City of Henderson
Fire Safety Engineering
Informational Bulletin

Issue 014

TOP TEN

COMMON ERRORS ON SPRINKLER DRAWINGS (PART 2 OF 2)

Arrangement of Sprinklers Under Two Sets of Open Joists - No Sheathing on Lower Joists.

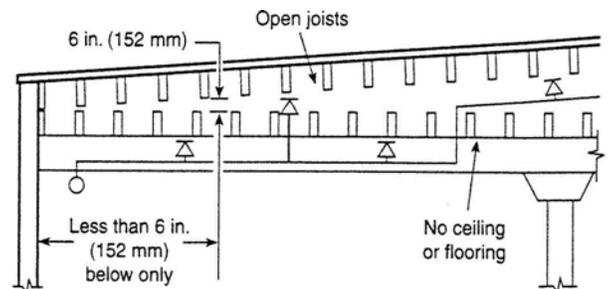
9. Attic coverage (upright heads) along roof trusses shall extend from the peak to the end of the truss, not to the point where the space between the top and bottom cords is $> 6"$ clear.
